# 7-ELEVEN

STORE #38421

STATE HIGHWAY NO. 66 & WILLOW BEND  
ROCKWALL, TEXAS 75087

"RECORD DRAWINGS"  
These drawings have been revised to show changes during the construction process reported by the contractor to Evolving Texas and considered significant. This drawing is not guaranteed to be "As Built", but is based on visual inspection and the information available and provided to Evolving Texas  
Date: 10/9/2019 By: *Samantha D. Renz*

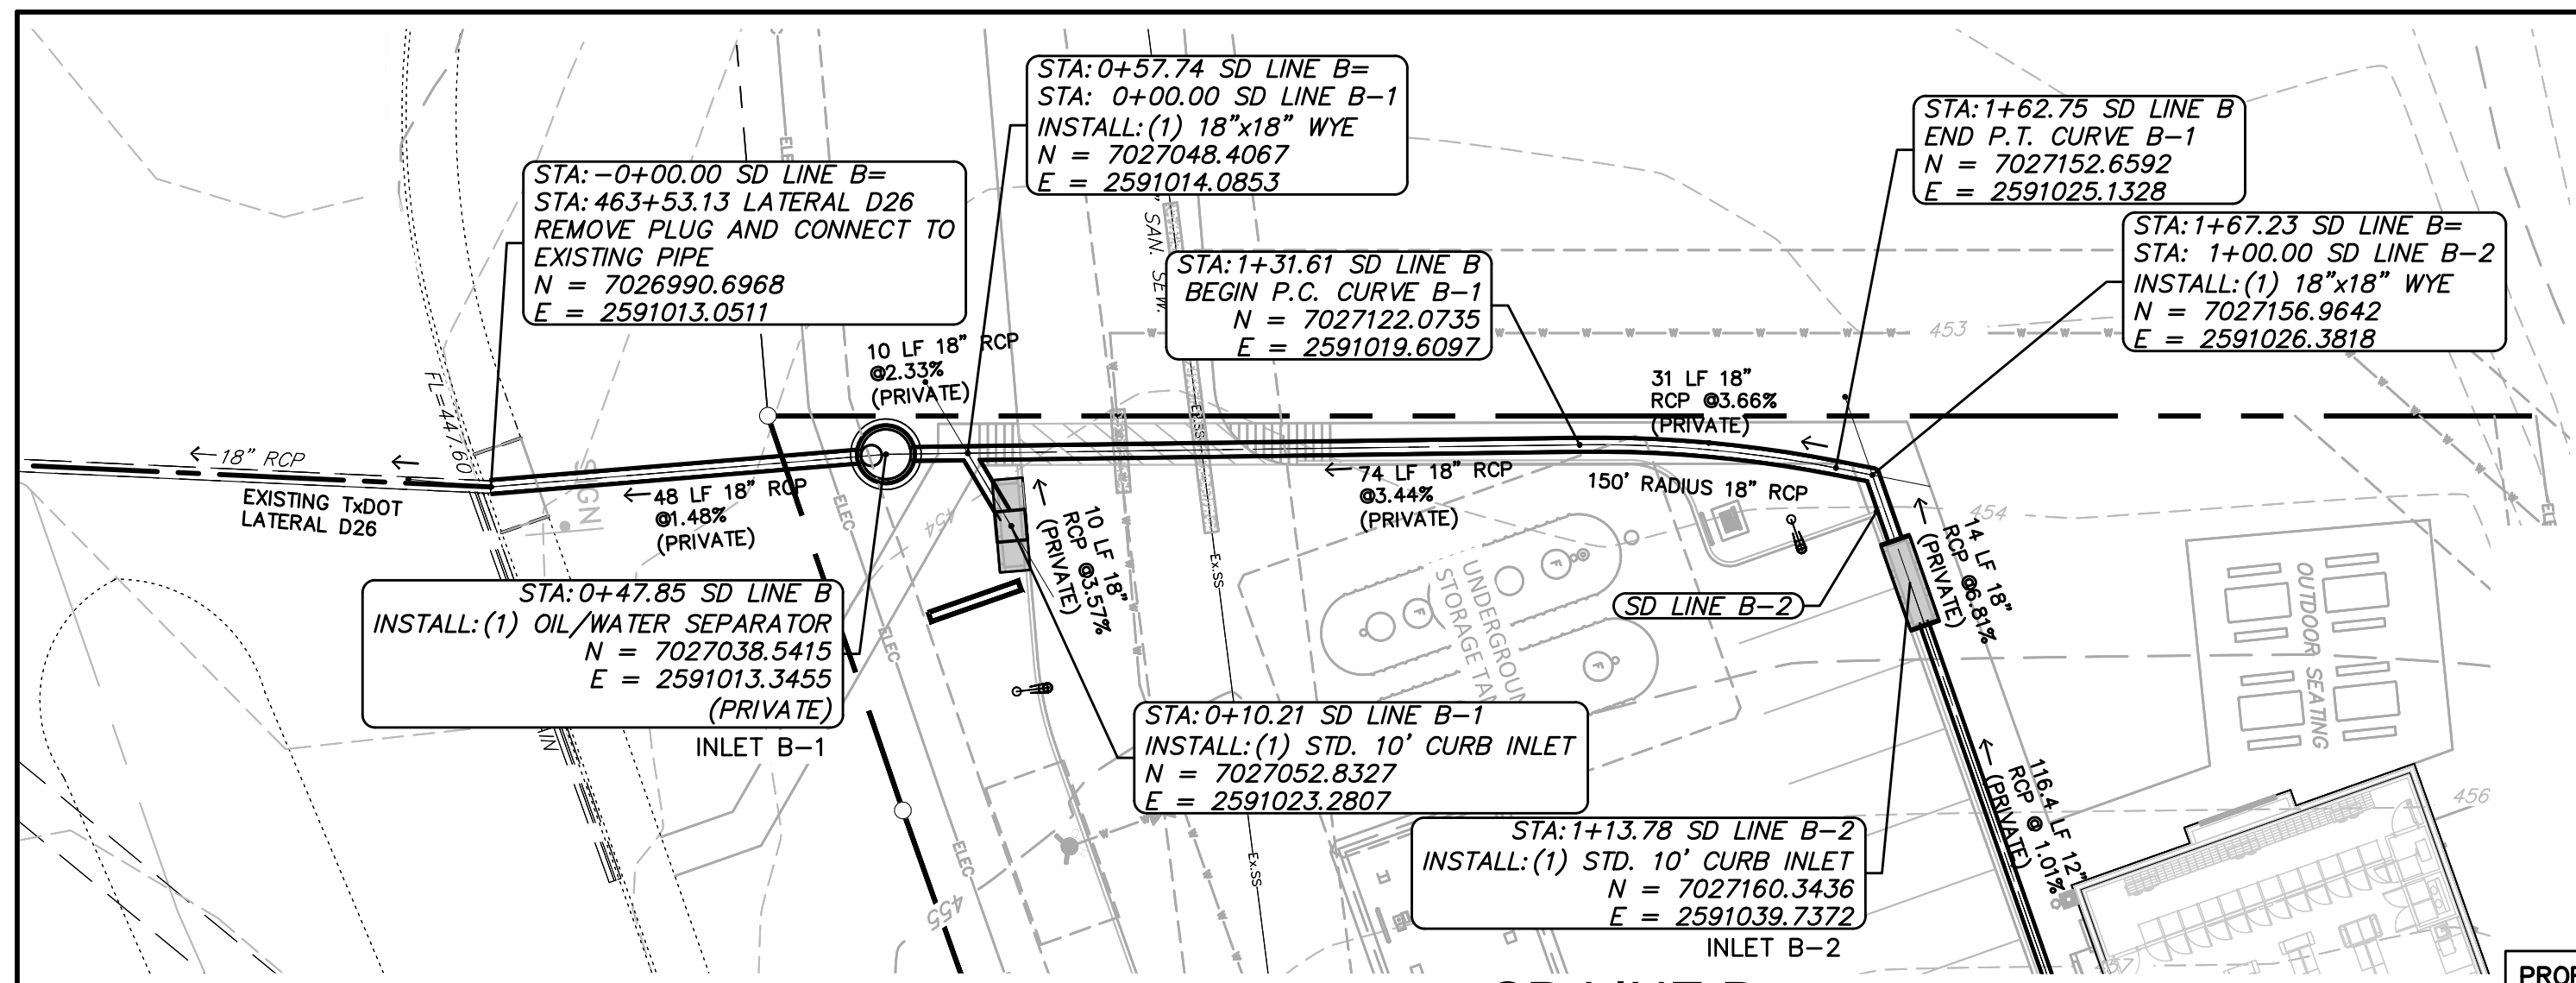
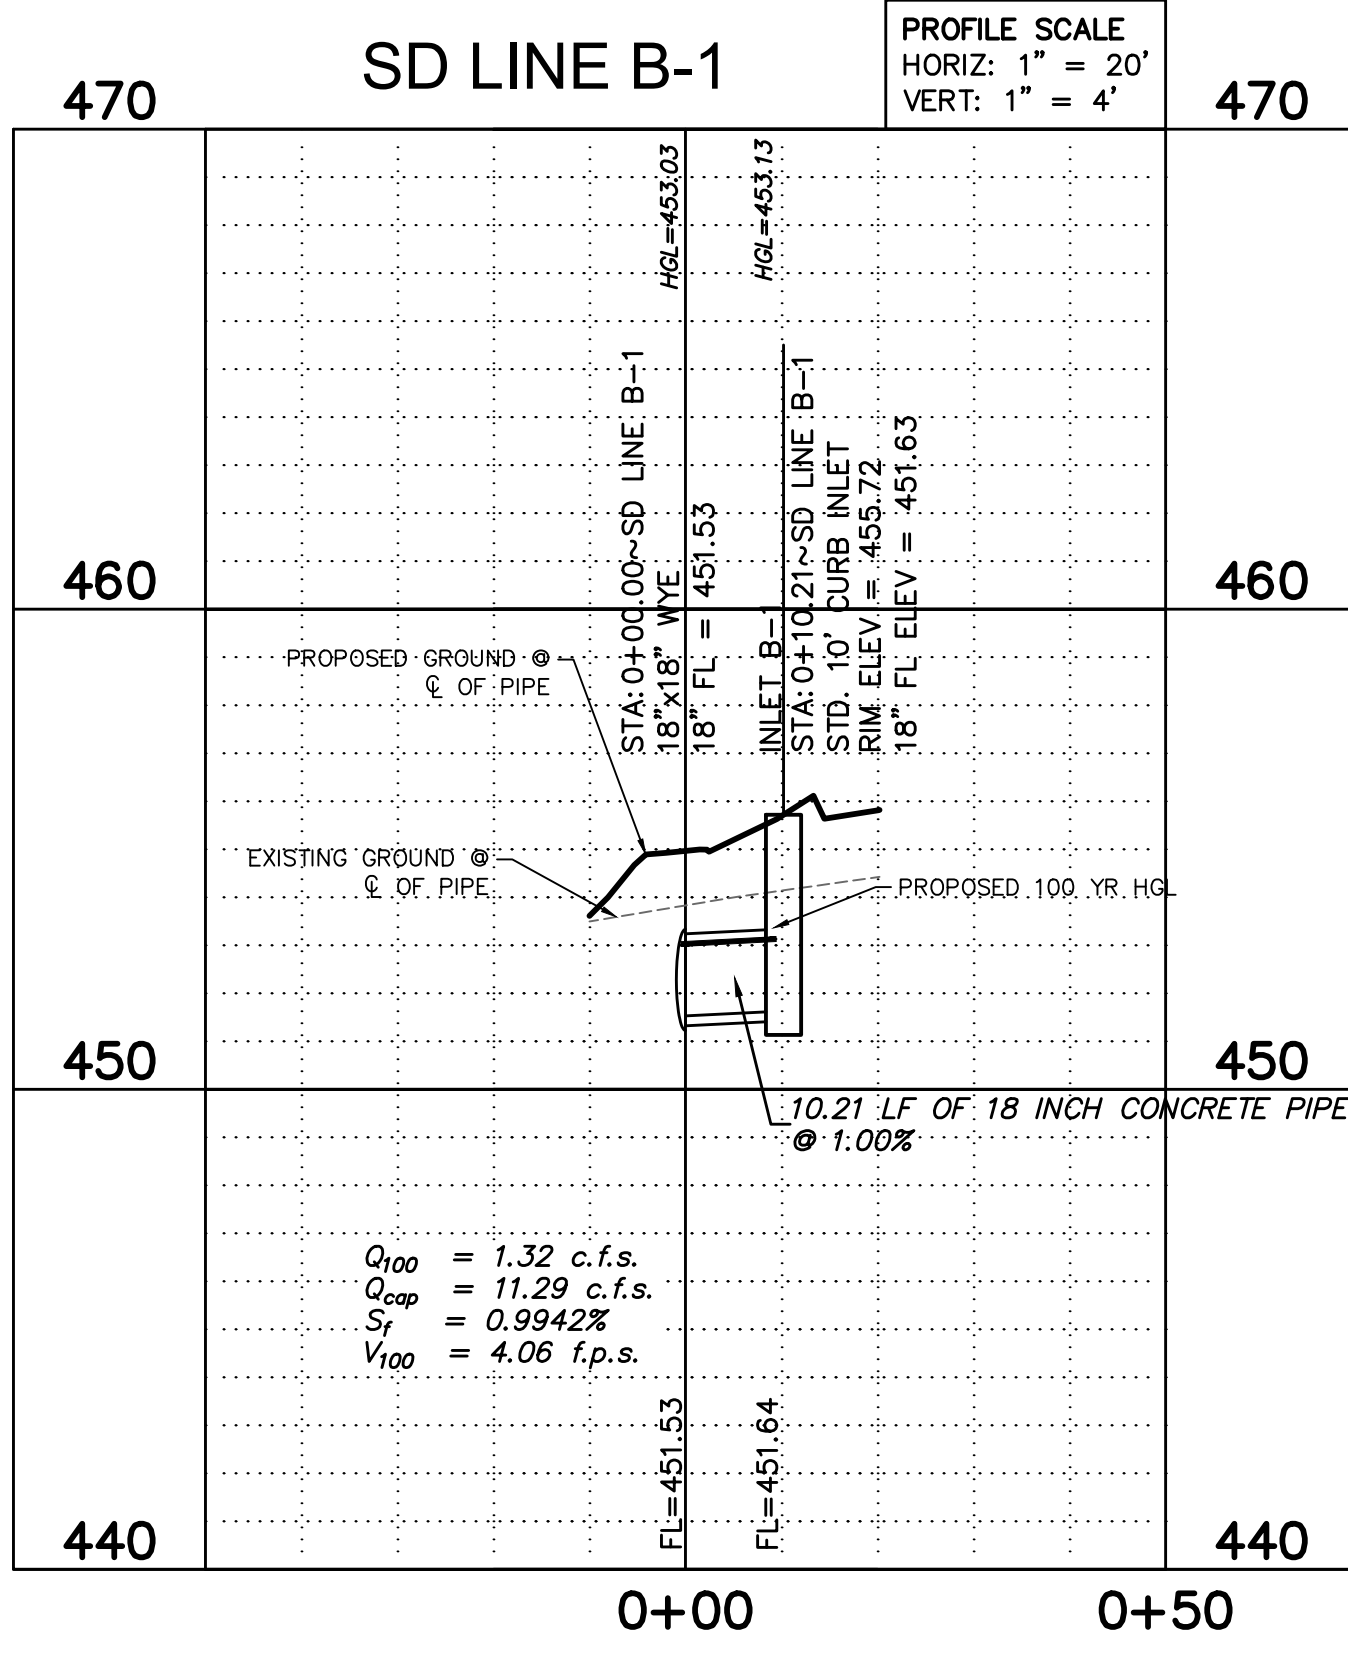
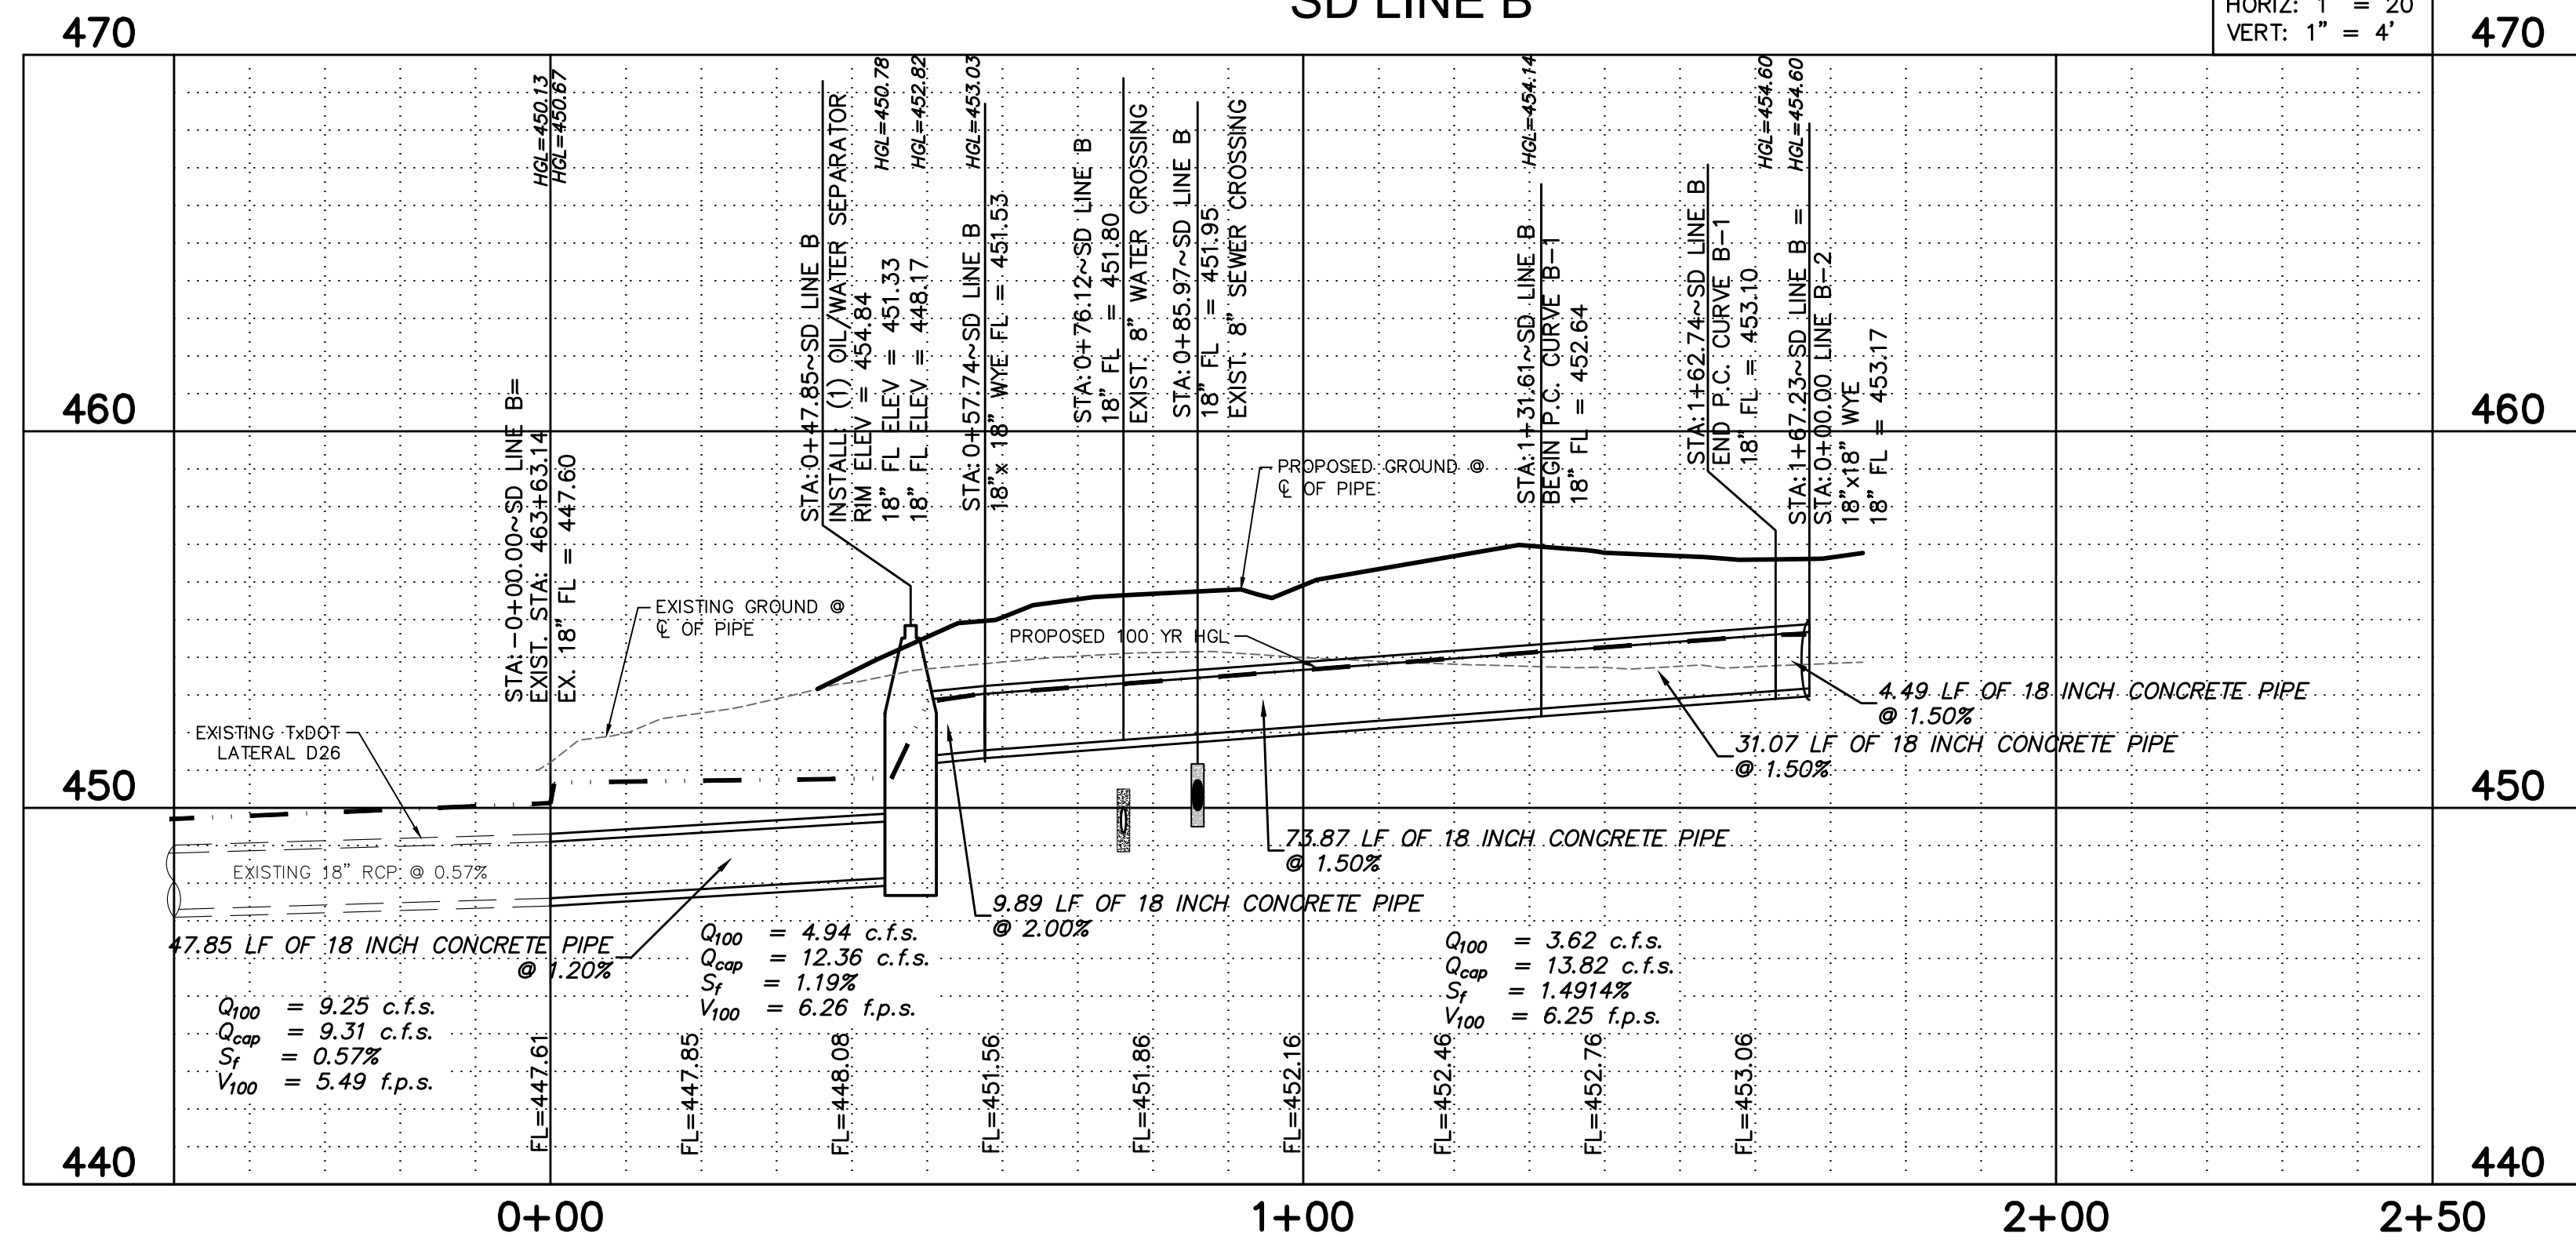
NO.	DATE	COMMENTS
1	1/21/19	Revised box culvert size to 4'x4' & HGL
2	2/1/19	Revised box culvert size from 4'x4' to 4'x5' & HGL
